The Commission has issued the enclosed Amendment Nos. 52, 52 and 49 for License Nos. DPR-38, DPR-47 and DPR-55 for the Oconee Nuclear Station, Unit Nos. 1, 2 and 3. These amendments consist of changes to the Station's common Technical Specifications and are in response to your request dated September 6, 1977.

These amendments revise the Technical Specifications to establish operating limits for Unit 3 Cycle 3 operation.

ATTACHMENT TO LICENSE AMENDMENTS

SAFETY EVALUATION BY THE OFFICE OF NUCLEAR REACTOR REGULATION

Figure 2.1-1C

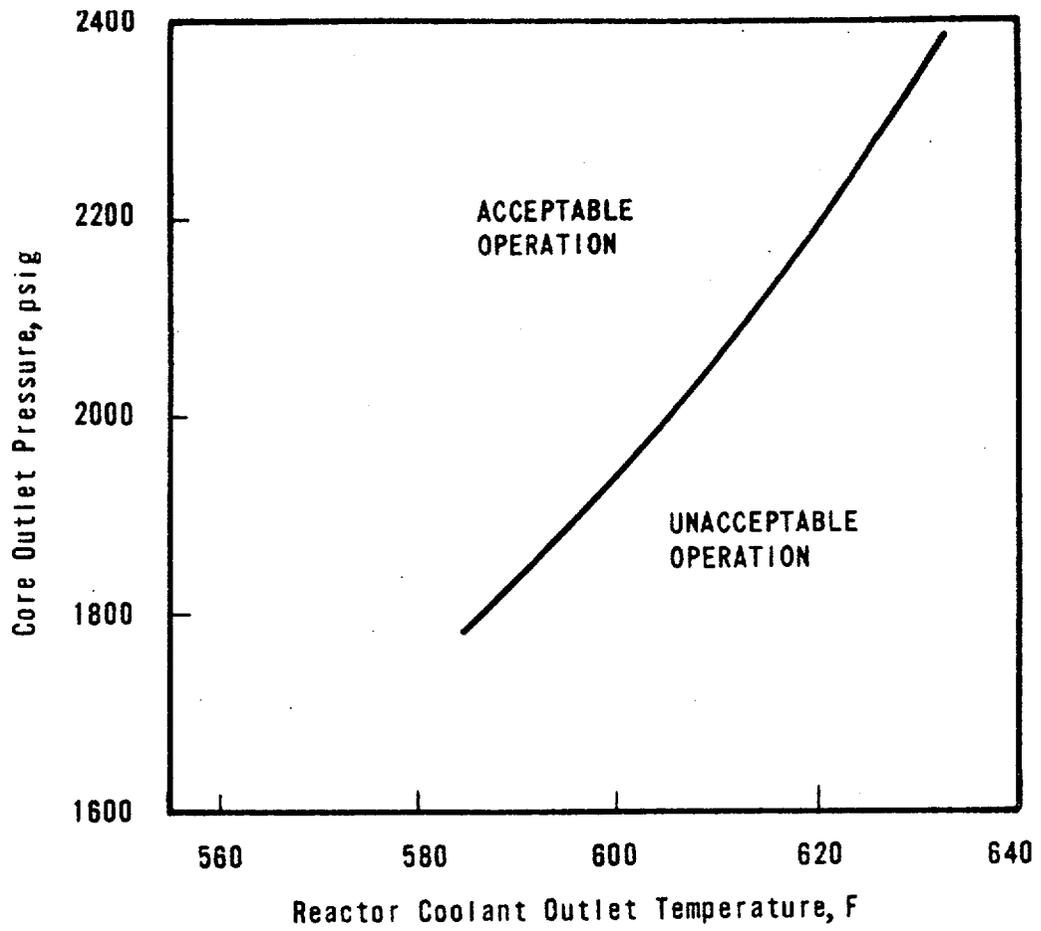
The curve presented in Figure 2.1-1C represents the conditions at which a minimum DNBR of 1.30 is predicted for the maximum possible thermal power (112 percent) when four reactor pumps are operating (minimum reactor coolant flow is 139.86×10^6 lbs/hr.). This curve is based on the following nuclear power peaking factors with potential fuel densification and fuel rod bowing effects: $F_q^N = 2.67$; $F_{\Delta H}^N = 1.78$; $F_z^N = 1.50$. The design peaking combination results in a more conservative DNBR than any other power shape that exists during normal operation.

The pressure-temperature limit curve shown in Figure 2.1-1C of the Technical Specifications provides the basis for the variable low-pressure trip setpoint. The curve shows for all modes of reactor operation locus of points for which the calculated minimum DNBR is equal to 1.30 (BAW-2) plus the margin required to offset an 11.2% DNBR reduction due to rod bow. The specific credits used in this analysis to account for rod bow are as follows:

Figure 2.1-2C

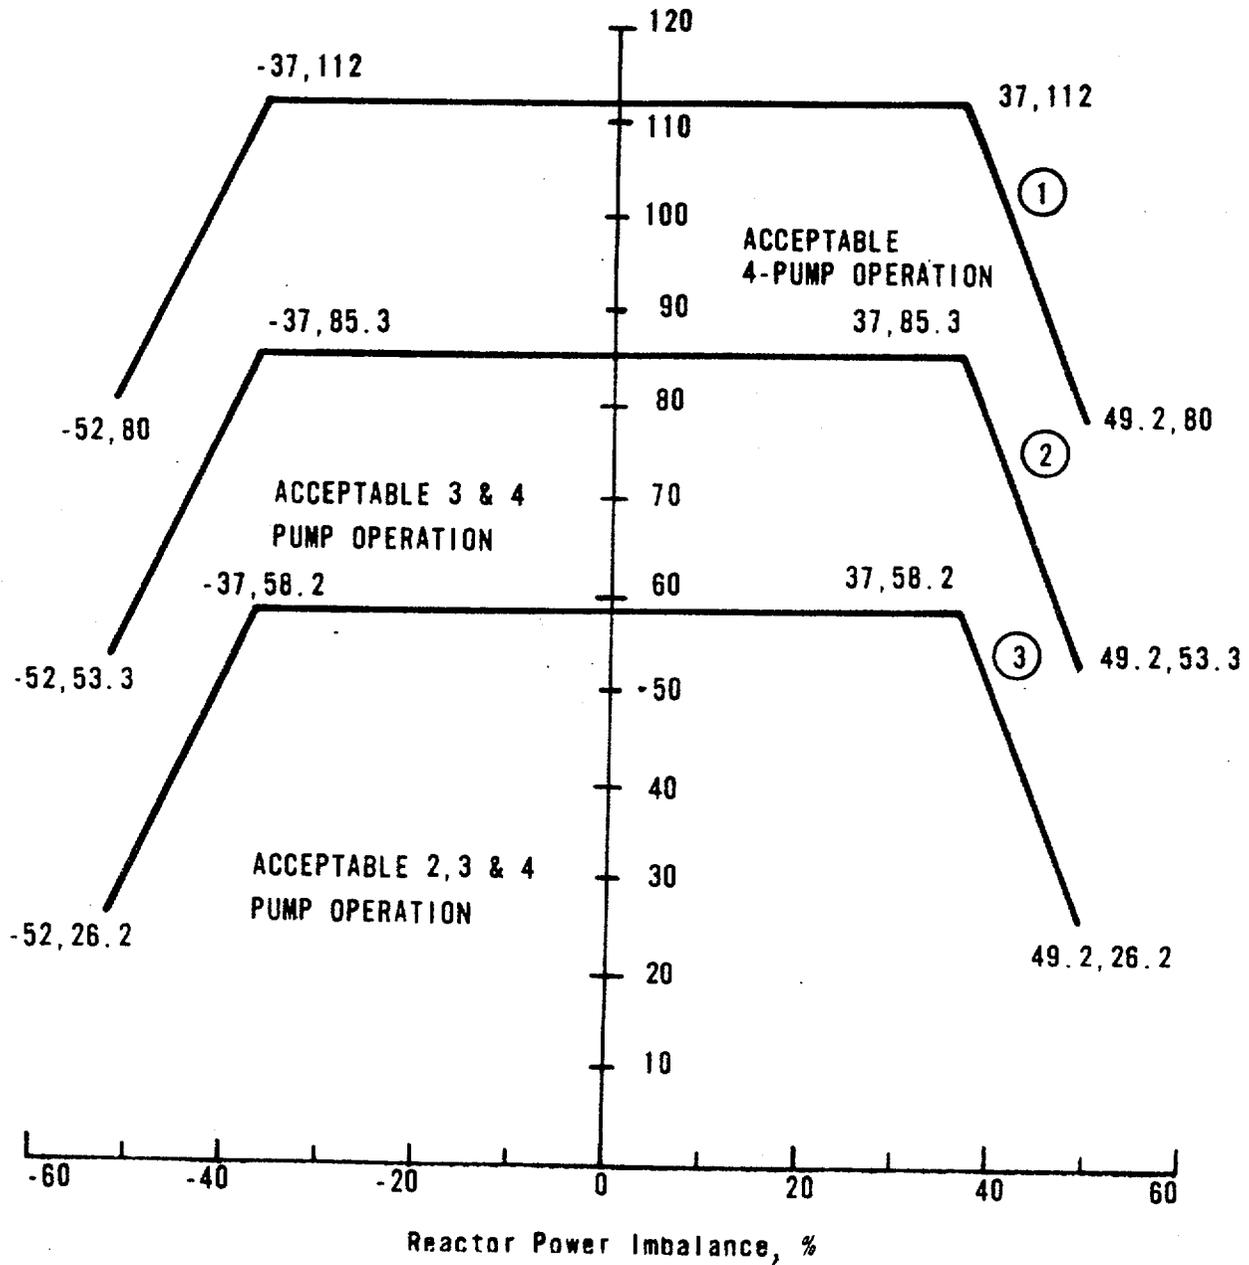
The curves of Figure 2.1-2C are based on the more restrictive of two thermal limits and include the effects of potential fuel densification and fuel rod bowing.

The specified flow rates for Curves 1, 2 and 3 of Figure 2.1-2C correspond to the expected minimum flow rates with four pumps, three pumps and one pump in each loop, respectively.

Figure 2.1-3C

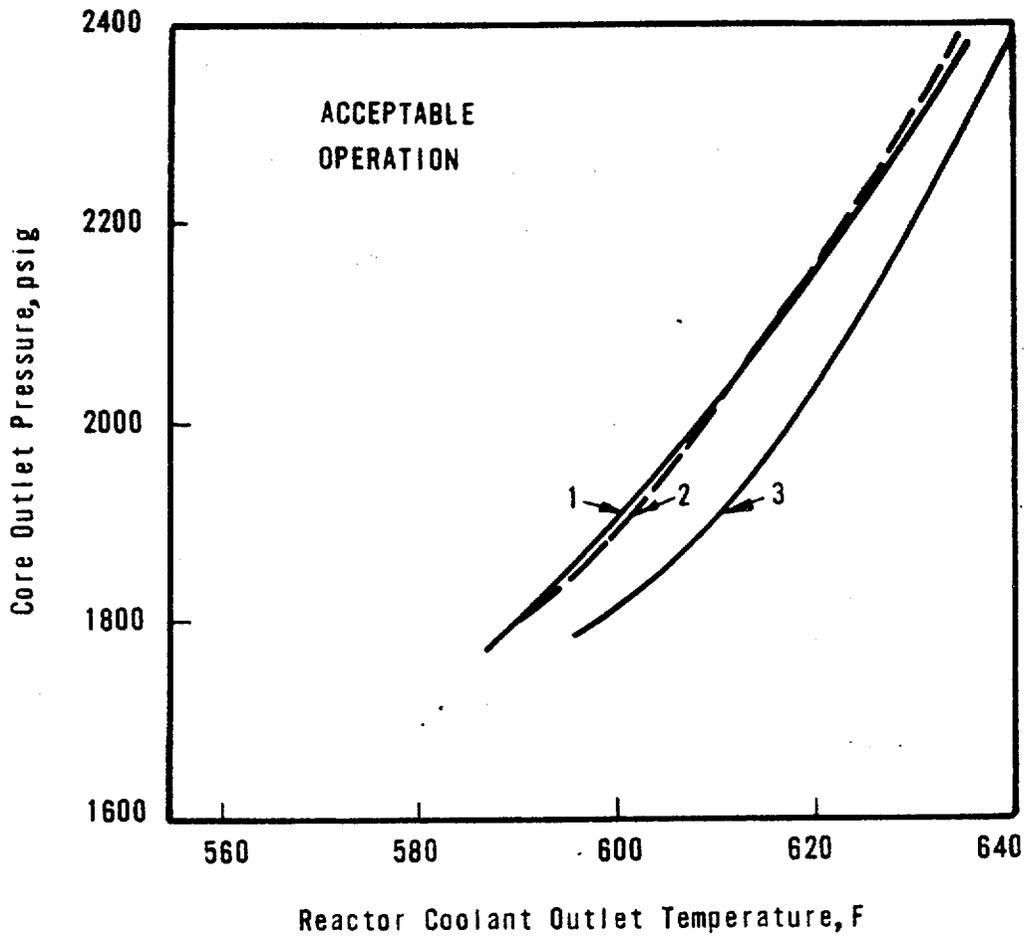
For each curve of Figure 2.1-3C a pressure-temperature point above and to the left of the curve would result in a DNBR greater than 1.30 or a local quality at the point of minimum DNBR less than 22 percent for that particular reactor coolant pump situation. The curve of Figure 2.1-1C is the most restrictive of all possible reactor coolant pump-maximum thermal power combinations shown in Figure 2.1-3C.
